MEETING MEMORANDUM

Pre-Request for Additional Information Meeting

PROJECT: Project Tiger – Airpark Site
REPORT BY: Parker Osterloh

PRE/POST DEVELOPMENT HYDROLOGY EXHIBIT

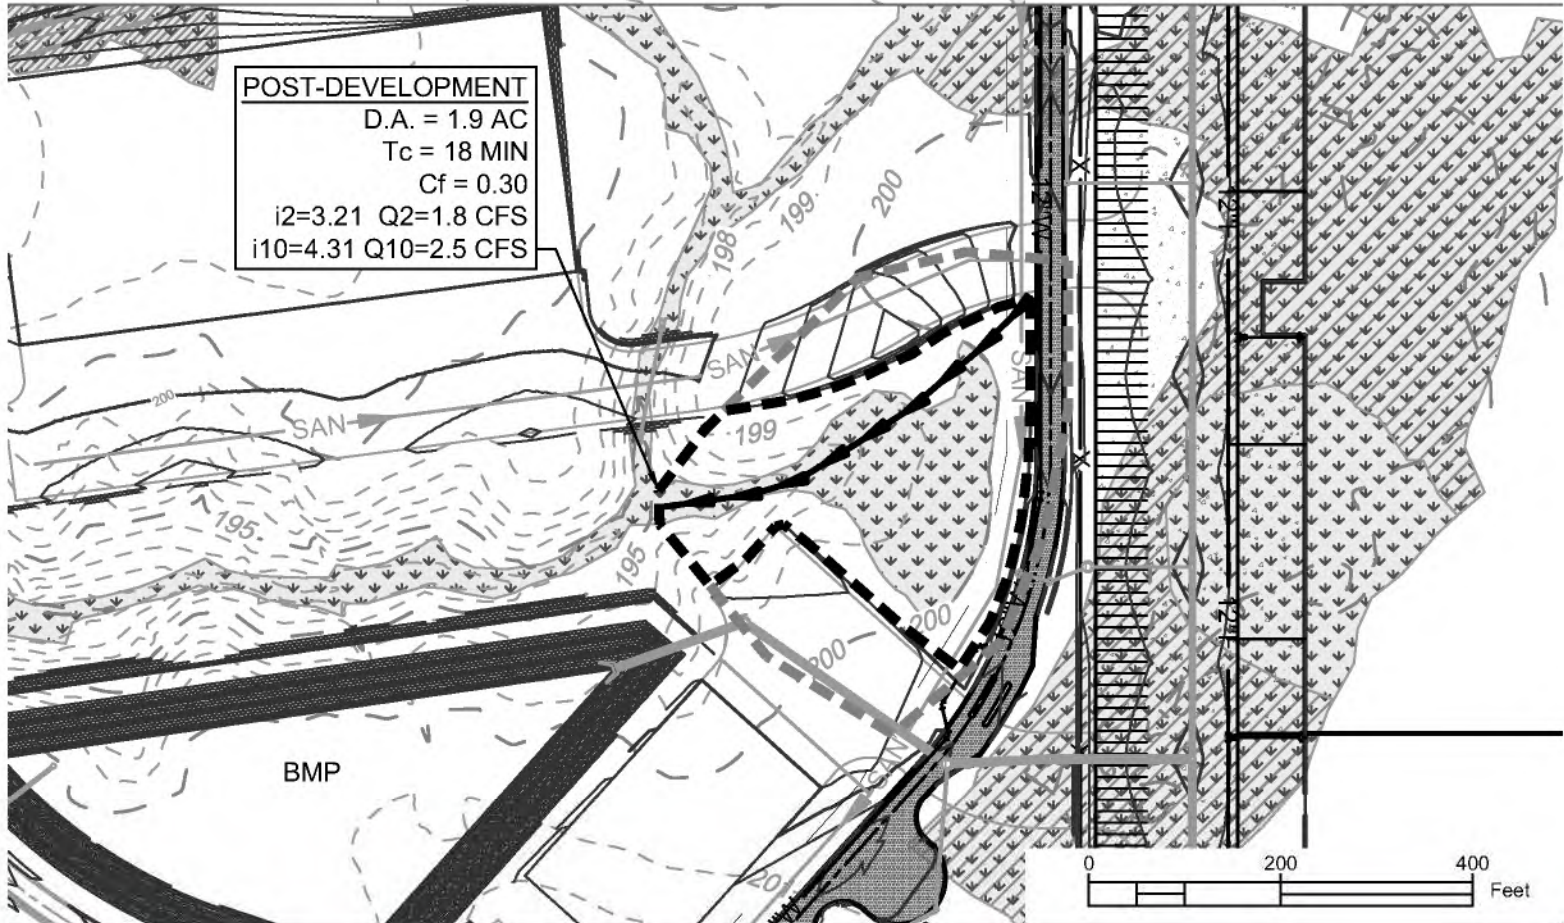
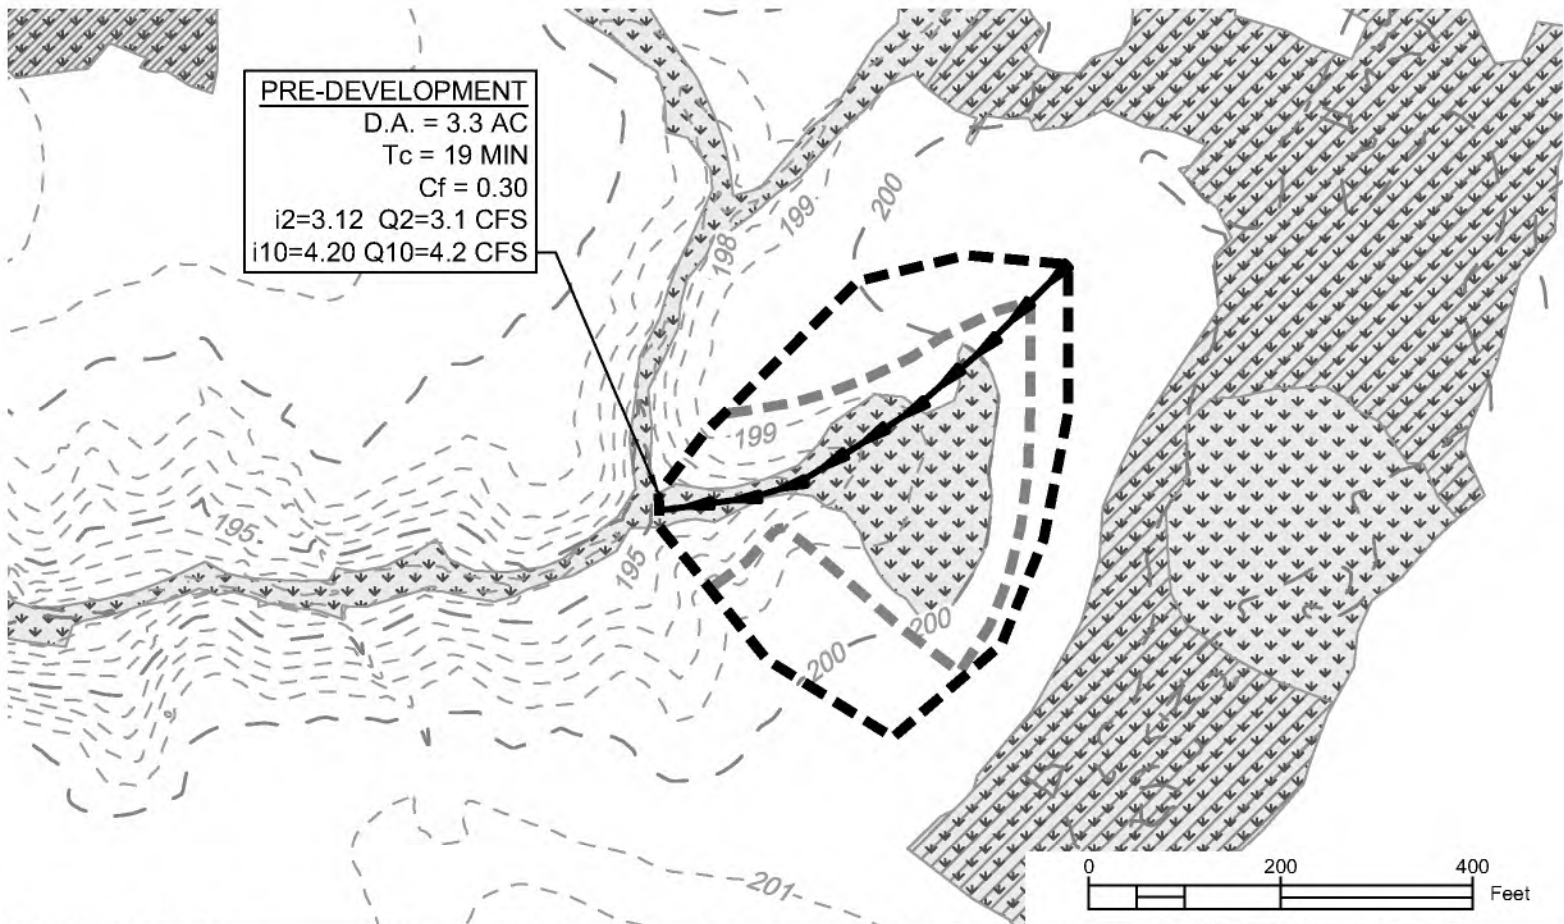
- 2) In accordance with 9 VAC 25-210-80 B 1.h, please provide detailed information describing how the remaining wetlands up gradient of Impact 22 will not be secondarily impacted as a result of this project. Will remaining surface waters still receive adequate hydrology post construction?

While there is certainly a decrease in the contributing drainage area to the confluence point with the main wetland system which would result in secondary impacts from the pre-development to post-development condition, the area immediately upland of the hammerhead wetland pocket itself is being reduced in a linear fashion along the drainage divide. There is no major contributing area being cut off, it is more so tightening up and reducing in size. Therefore, direct rainfall to this pocket in the post-development condition will still maintain some hydrology within the existing system. See Pre and Post Flow Calculations exhibit for rational method peak flow comparison at the confluence point. Peak

As such, the applicant proposes compensatory mitigation for 40% of the secondarily impacted area, which would result 0.35 acres (15,043 square feet) of impacts requiring the purchase of 0.7 compensatory mitigation credits, which has been included in Figure 5: Preliminary Jurisdictional Waters of the U.S. Impacts Map and Wetlands and Waters Impacts Table, as well as the Required Mitigation Table.
